ADDENDUM NO. 2

Project: **ROOF REPLACEMENT FOR VALLEY REGIONAL FIRE AND RESCUE**

ADDENDUM NO. 1

ADDENDUM NO. 1 - DETAIL 3/G3/G3 REISSUE

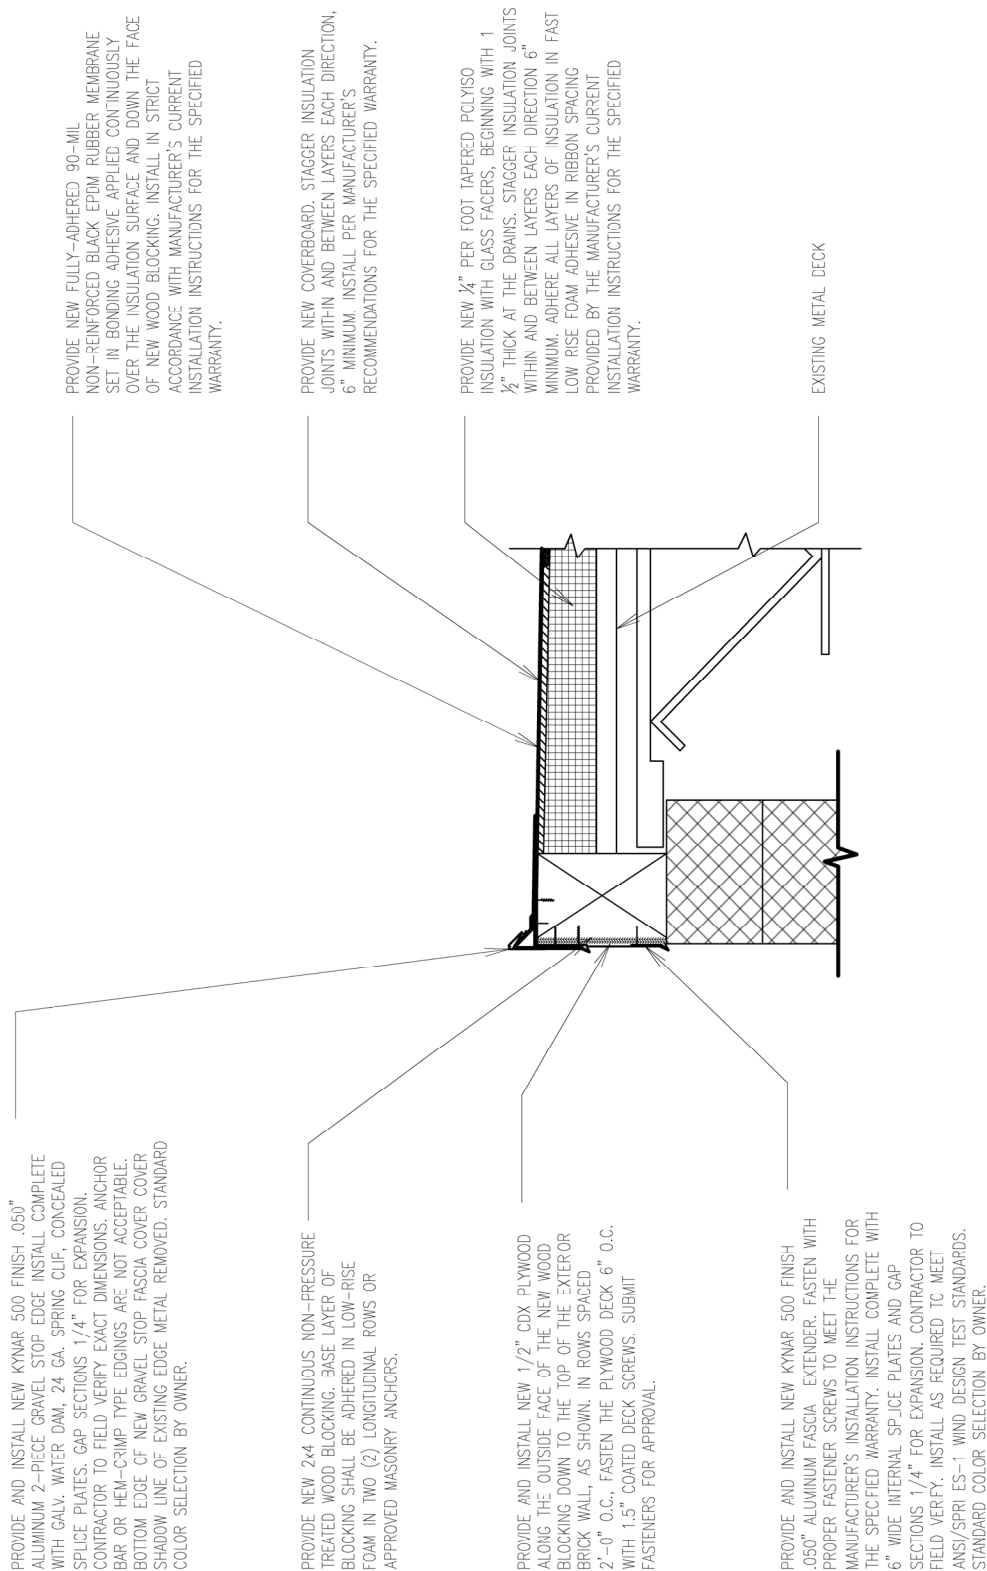
- D. As a clarification, Proposed Roof Section 3/G3/G3 on Drawing Sheet G3 notation was cut off and did not appear as intended. Please refer to the attached SK1 drawing reissuing the section as intended.
